Product hierarchy no. *			chy no. *	Part no.	SBU	Type / Description	Customer part no.
SBU	PG	PUG	Туре				
01	002	002	0000000510	See list below	Fuseholder (complete and socket)	FIZ	
01	002	063	COCCOCCACT	See list below	Fuseholder (carrier)	FIZ

Product Change Notification					FIZ	Z plastic material change		
owner	creation date	release date	released by	change order no	rev	page	D40 007 050	
zbindeja	2016-08-11	2016-10-07	nowakfr	2010727	Α	1 of 2	D10-007-250

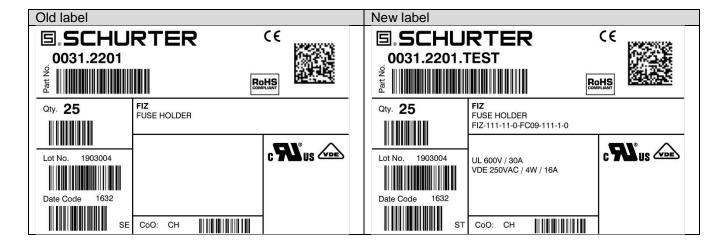
- Change of material
- Modified label

- Product improvement to fulfil the enhanced glow wire requirements according to the updated standard IEC 60127-6 and the standard IEC 60335-1 for appliances in unattended use.
- Recertification by VDE

Form Yes Change plastic material
Fit No No change for dimension
Function No No change in function

Label Yes Electrical ratings added, configuration code added
